**FACILITY COMPLIANCE AUDIT REPORT**  
**Division of Waste Management**  
**Solid Waste Section**

Lined MSWLF		LCID		YW		Transfer		Compost		SLAS		<b>COUNTY: McDowell</b> <b>PERMIT NO.: 56 - 01</b> <b>FILE TYPE: COMPLIANCE</b>
Closed MSWLF	<b>X</b>	HHW		White goods		Incin		T&P		FIRM		
CDLF		Tire T&P / Collection		Tire Monofill		Industrial Landfill		DEMO		SDTF

McDowell MSW – Closed October 7, 1994  
 2849 NC Hwy 226 S.  
 Marion, NC 28752

Comprehensive Audit.

Figure #1. McDowell County GIS aerial. (Approximate limits of Waste disposal areas and monitoring well locations.)

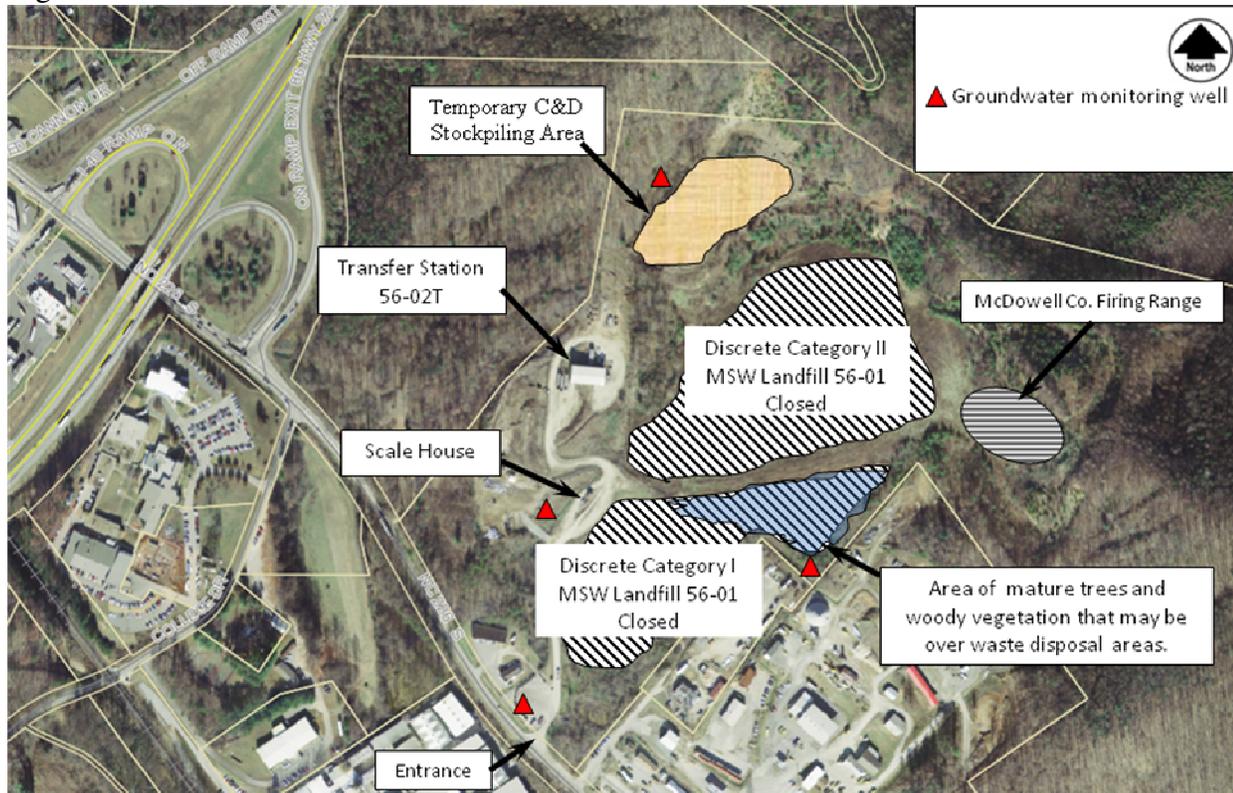
- The closed McDowell County municipal solid waste (MSW) landfill consists of two separate areas: “Discrete Category I Landfill” and “Discrete Category II Landfill”. (Figure 1)

4. During the audit, four groundwater monitoring wells were located. (Figure 1 and Photos #7 through #13).

**Within 90-days of your receipt of this report, please ensure that all of the groundwater monitoring wells are secured with locking well caps; marked with permanent, unique, identification plates; and are identified on an updated site map.**
